## TRANSBAY JOINT POWERS AUTHORITY

### REQUEST FOR PROPOSALS No. 18-02 TWO-WAY RADIO SYSTEM

#### *QUESTIONS & ANSWERS*

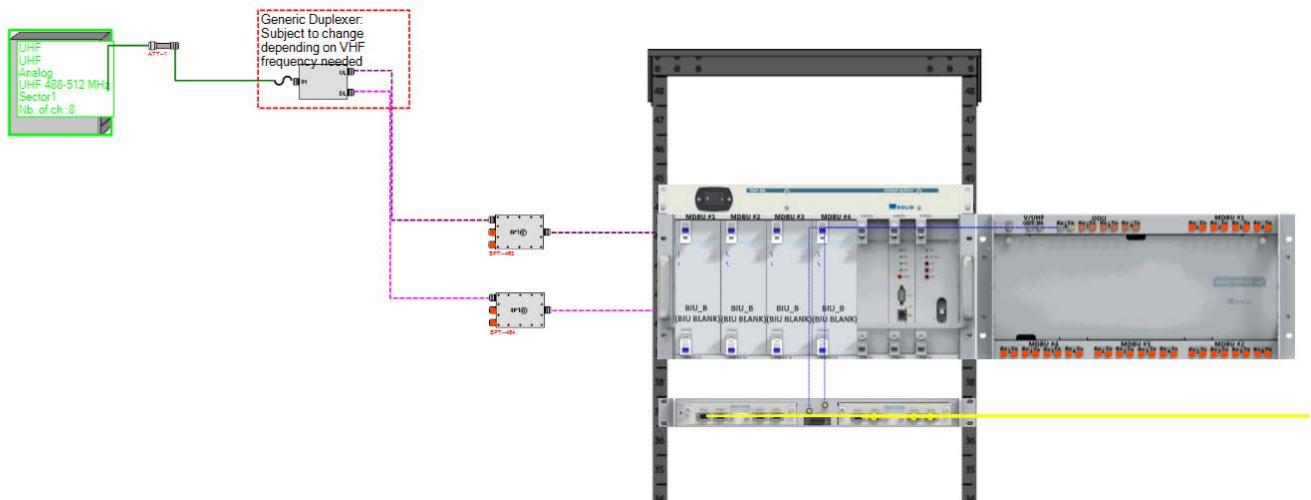
25. **Q: What is the physical and electrical interface to the Distributed Antenna System (DAS) being installed by Boingo on all the platform levels?**

A: A hard line is expected from the UHF source to the DAS interface (BIU). See below:
